# DEVIATION REQUEST AND DECISION FORM

Project Name: Sterling Ranch Sand Creek Channel Construction Drawing Review CDR 20-4 Schedule No.(s): 5227301021, 5233309027, 5228000030 & 38, 5233301001 5233301016 & 47

A deviation from the standards of or in Section ECM section 3.3.3 Open Channel Design Standards of the Engineering Criteria
Manual (ECM) is requested for the Sand Creek Channel Design – Low Flow Channel Capacity.
Identify the specific ECM standard which a deviation is requested:

Exhibit A
Sterling Ranch - Sand Creek Channel - Drop Structures

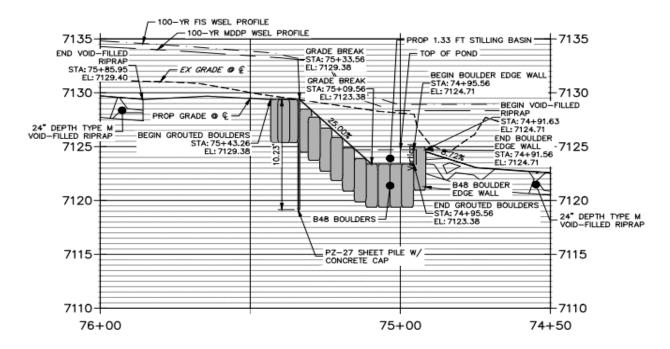
Per ECM Section 3.3.3 Item B. All open channels shall conform to DCM Volume 1 and Volume 2. Per DCM Vol. 1 chapter 6.5 Open Channel Design Criteria, Section 5 Drop Structures, drop structures are to be four feet or less in height.
Open Channel Design Criteria, Section 5 Drop Structures, drop structures are to be four feet or less in height.
State the reason for the requested deviation.
State the reason for the requested deviation:
Drop structures were placed strategically to reduce the amount of disturbance to the existing wetland corridor within the channel.
Drop heights were also determined based upon wetland preservation which required some of the drop structures to exceed the
four foot height criteria.
Tour foot fleight official.
Explain the proposed alternative and compare to the ECM standards (May provide applicable regional or national standards used
as basis):
See Exhibit A for a table of the various drop heights used in the Sand Creek Channel plans along with a representative cross

section of the general design.
In the design there are 9 grouted houlder drop structures. Soven are typically configured with great too, gilling begin and sill wall
In the design there are 8 grouted boulder drop structures. Seven are typically configured with crest, toe, stilling basin and sill wall
and serve to reduce channel longitudinal slope thereby decreasing flow velocities. One drop (GSB #6) is used as a rundown into
existing stock pond #2 in the reach above Briargate Parkway and the toe is below the existing water surface, therefore this drop
existing stock pond #2 in the reach above Briargate Parkway and the toe is below the existing water surface, therefore this drop
existing stock pond #2 in the reach above Briargate Parkway and the toe is below the existing water surface, therefore this drop
existing stock pond #2 in the reach above Briargate Parkway and the toe is below the existing water surface, therefore this drop

<b>LIMITS OF CONSIDERATION</b> (At least one of the conditions listed below must be met for this deviation request to be considered.)
<ul> <li>□ The ECM standard is inapplicable to the particular situation.</li> <li>□ Topography, right-of-way, or other geographical conditions or impediments impose an undue hardship and an equivalent alternative that can accomplish the same design objective is available and does not compromise public safety or accessibility.</li> <li>☑ A change to a standard is required to address a specific design or construction problem, and if not modified, the standard will impose an undue hardship on the applicant with little or no material benefit to the public.</li> </ul>
Provide justification:  Drop heights were sized to promote existing wetland preservation. Drop heights in this design are 6 feet or less when measured
from crest to toe and 4.7 feet when measured from crest to sill wall of the stilling basin.

The ECM does allow for drop structure heights above four feet if supported by geotechnical investigations and appropriate measures are incorporated into the drop structure design to relieve hydrostatic groundwater pressure on the drop. Each of the 8 drop structures will have a sheet pile integrated into the crest of drop structure and will have a weep hole system to relieve hydrostatic groundwater pressure even regardless of height.
CRITERIA FOR APPROVAL
Per ECM section 5.8.7 the request for a deviation may be considered if the request is <b>not based exclusively on financial considerations</b> . The deviation must not be detrimental to public safety or surrounding property. The applicant must include supporting information demonstrating compliance with <b>all of the following criteria</b> :
The deviation will achieve the intended result with a comparable or superior design and quality of improvement.  This request is not based on financial considerations. The primary reason for the exceeding the four foot drop height criteria was to lessen disturbance to the existing wetland corridor.

equest has been determined to have met the granted based on the justification provides	e criteria for approval. A deviation from Section	3.3.3 Item B.	of the ECM is
Γ L	Approved  By: Gilbert LaForce, P.E. Engineering Manager Date: 11/08/2023 9:20:04 AM El Paso County Department of Public Works	ر ا		
This r	d by the ECM Administrator equest has been determined not to have mey denied.	et criteria for approval. A deviation from Section		of the ECM is
Γ		Т		
L		Л		
-014		one.
